SDP/ENFORCEMENT PANEL WORKSHEET
Point Beach AFW Recirculation Valves

Date of Panel: February 21, 2002

Facility/Location: Point Beach

Inspection Report No: 50-266/01-17; 50-301/01-17

AFW System - Major Flow Paths

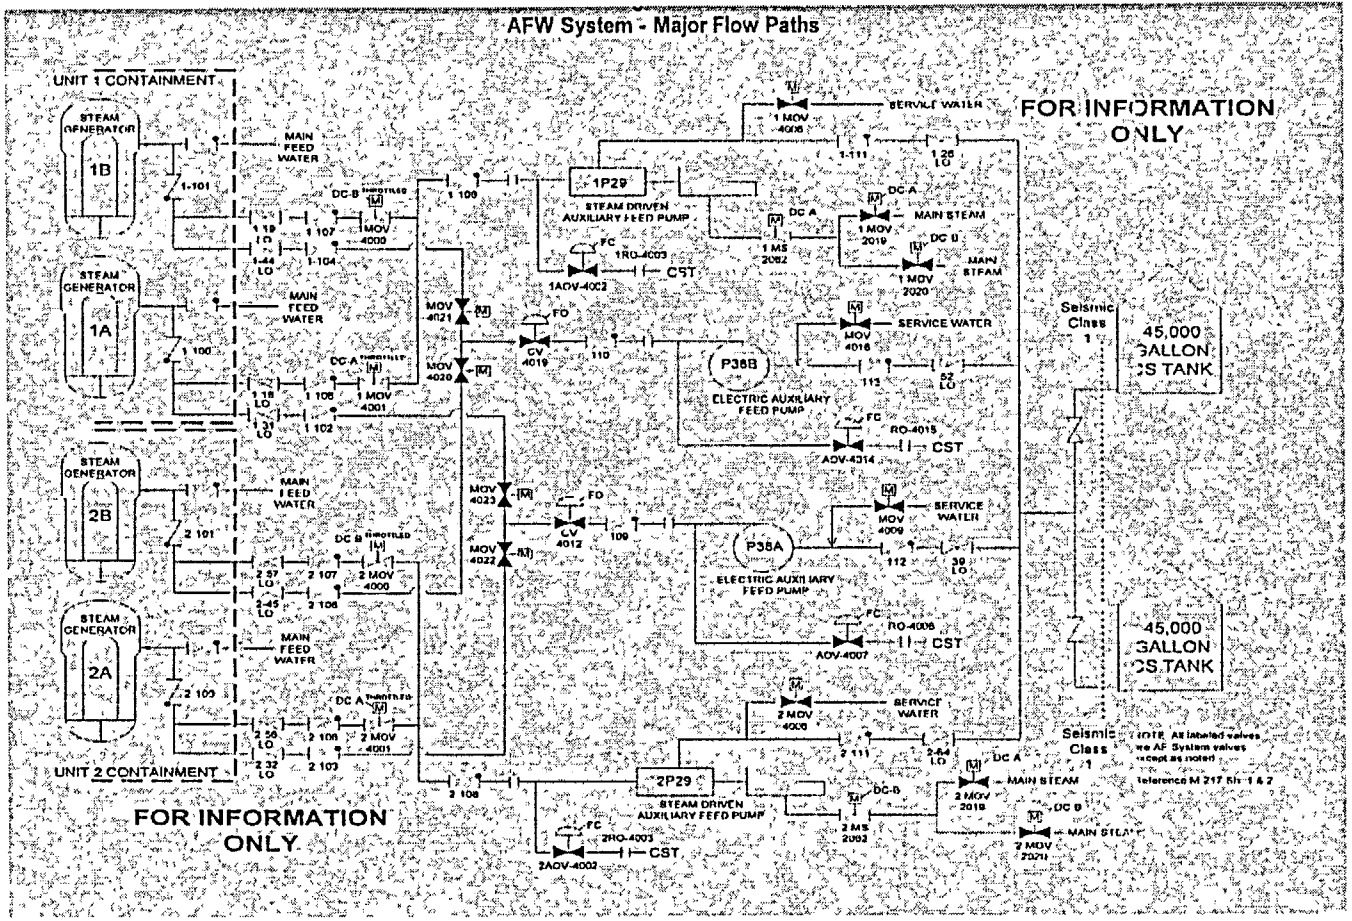
Nuclear Management Company (the licensee for Pt. Beach) identified that there was a potential for dead-heading auxiliary feedwater (AFW) pumps due to the AFW minimum flow recirculation valves failing closed. In a dead-headed condition, the pumps would fail within minutes due to overheating. The dead-heading could occur either through operator actions in response to a transient or by a fire in the Unit 1 turbine driven AFW pumps. The AFW minimum flow recirculation valves at Pt. Beach, by original design, fail closed upon a loss of instrument air. Certain transients, such as loss of off-site power (LOOP), loss of instrument air (LOIA), loss of service water (LOSW), and seismic event, will result in a loss of instrument air. Additionally, certain fire scenarios could cause the AFW minimum flow recirculation valves to fail closed due to fire induced damage to instrument air lines or the control cables for the valves. A draft of the inspection report body is included at Attachment 3.

The licensee also identified that the AFW pump relied upon to provide AFW flow to a Unit 1 steam generator could be in dead-headed condition due to a Unit 1 turbine driven AFW pump fire. Specifically, the fire could damage the Unit 1 turbine driven pump, the "A" train motor driven AFW pump power cables, and the Unit 1 discharge valve from the "B" train motor driven AFW pump. Fire damage to either the instrument air lines in the area or the control cables for the "B" train motor driven pump could also result in the minimum flow recirculation valve for the "B" train motor driven pump to fail closed. Consequently, the "B" train motor driven pump would be in a dead-headed condition when a start signal is received. No other AFW pumps would be available to supply a Unit 1 steam generator.
